Product Update Memo

SENSORS & CONTROLS PRODUCTS

June, 2006

Model EN Optical Encoder Series Material Change

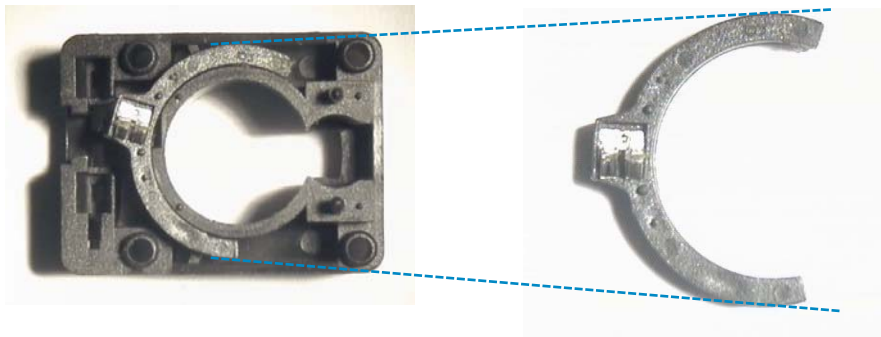
Sensors and Controls Division will be changing the plastic material used in molding the LED trimming rotor of the **Model EN** Optical Encoder. A change will be made from Fortron 1140L4 to Thermocomp® OF-1008 due to phase out of Fortron material at our current supplier and lack of availability from other suppliers.

Thermocomp® material is equivalent to the Fortron material and has been qualified for use in the standard EN Series product. Please reference the attached photo identifying the rotor. There is no change in form, fit or function.
